# **Nine Mile Point 3 Nuclear Power Plant**

## **Combined License Application**

### **Part 4: Technical Specifications and Bases**

## Section A – Departures and Supplements

Figure 3.7.16-1 (page 1 of 1)

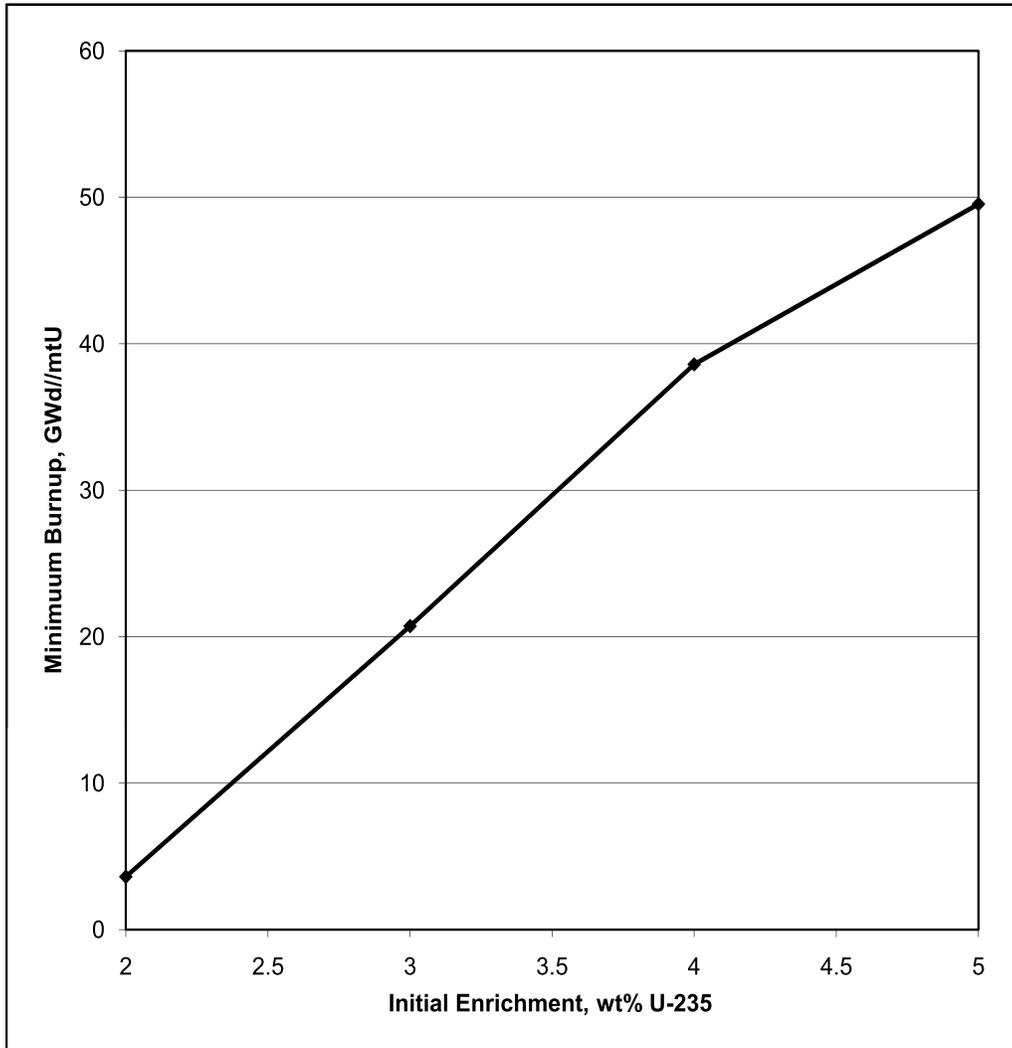
{NMP3NPP} TS and Bases 3.7.16, “Spent Fuel Storage,” are revised to remove the Reviewer’s Note and include the {NMP3NPP} specific spent fuel storage requirements in the TS and Bases, including the addition of Figure 3.7.16-1, “Fuel Assembly Burnup Requirements for Region 2.” The associated Bases (all sections) are also revised to include a discussion of the bases for the specific spent fuel storage requirements.

The {NMP3NPP} specific TS and Bases 3.7.16 are revised to reflect the results of the design and analyses of the {NMP3NPP} specific spent fuel racks described in the Holtec Topical Report for the design and analyses of the U.S. EPR spent fuel storage racks.

LCO 3.7.16 ~~Fuel shall be stored in approved locations in the spent fuel storage pool. The combination of initial enrichment and burnup of each fuel assembly stored in Region 2 of the spent fuel storage pool shall be within the limits specified in Figure 3.7.16-1.~~

Figure 4.3-1 (page 1 of 1)  
Discrete Two Region Spent Fuel Pool Rack Layout

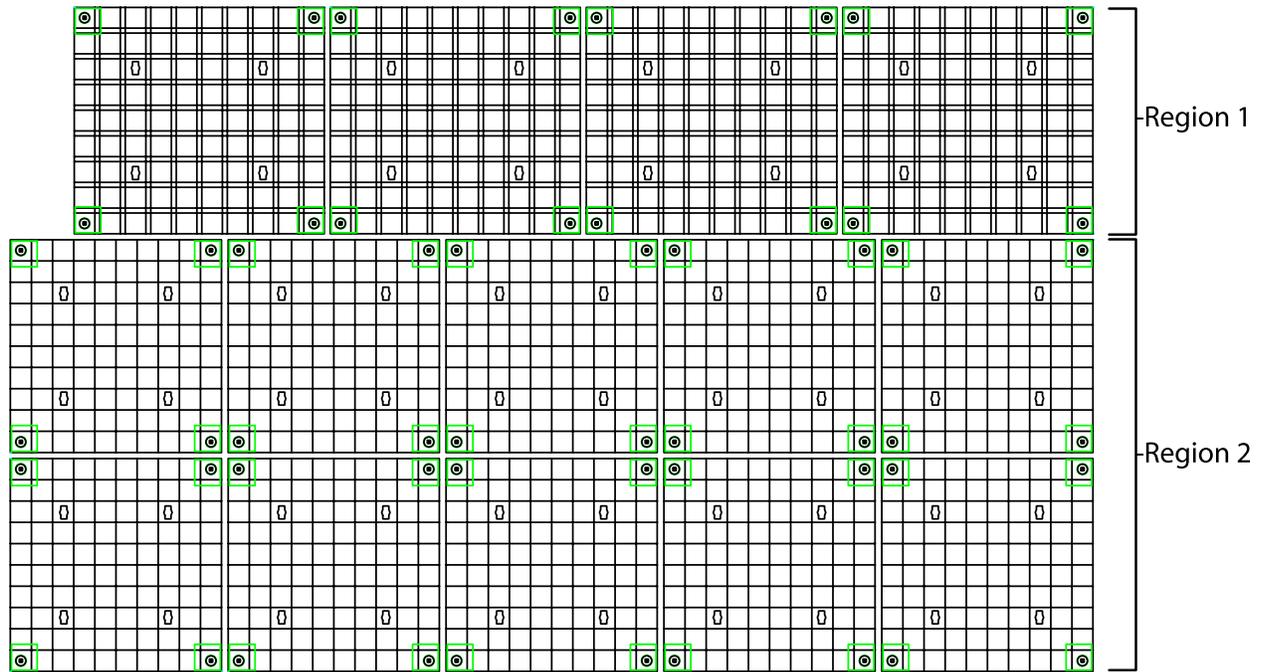
{NMP3NPP} TS 4.3.1.1.c is revised to include the spent fuel rack center to center distances between fuel assemblies stored in Region 1 and for fuel assemblies stored in Region 2 of the {NMP3NPP} spent fuel racks. In addition, restrictions on the storage of fuel assemblies are established in TS 4.3.1.1.d and 4.3.1.1.e. Figure 4.3-1, "Discrete Two Region Spent Fuel Pool Rack Layout" is added to identify the storage cells associated with Region 1 and the storage cells associated with Region 2.

{NMP3NPP} specific TS 4.3.1.1 requirements are revised to reflect the results of the design and analyses of the {NMP3NPP} specific spent fuel racks described in the Holtec Topical Report for the design and analyses of the U.S. EPR spent fuel storage racks.

{NMP3NPP} TS 4.3.3 is revised to include capacity for spent fuel storage in the {NMP3NPP} spent fuel storage pool.

{NMP3NPP} specific TS 4.3.3 requirements are revised to reflect the spent fuel storage capacity resulting from the design and analyses of the {NMP3NPP} specific spent fuel racks described in the Holtec Topical Report for the design and analyses of the U.S. EPR spent fuel storage racks.

d. New or partially spent fuel assemblies with any discharge burnup may be allowed unrestricted storage in Region 1 of Figure 4.3-1;

e. Partially spent fuel assemblies meeting the initial enrichment and burnup requirements of LCO 3.7.16, "Spent Fuel Storage," may be stored in Region 2 of Figure 4.3-1.
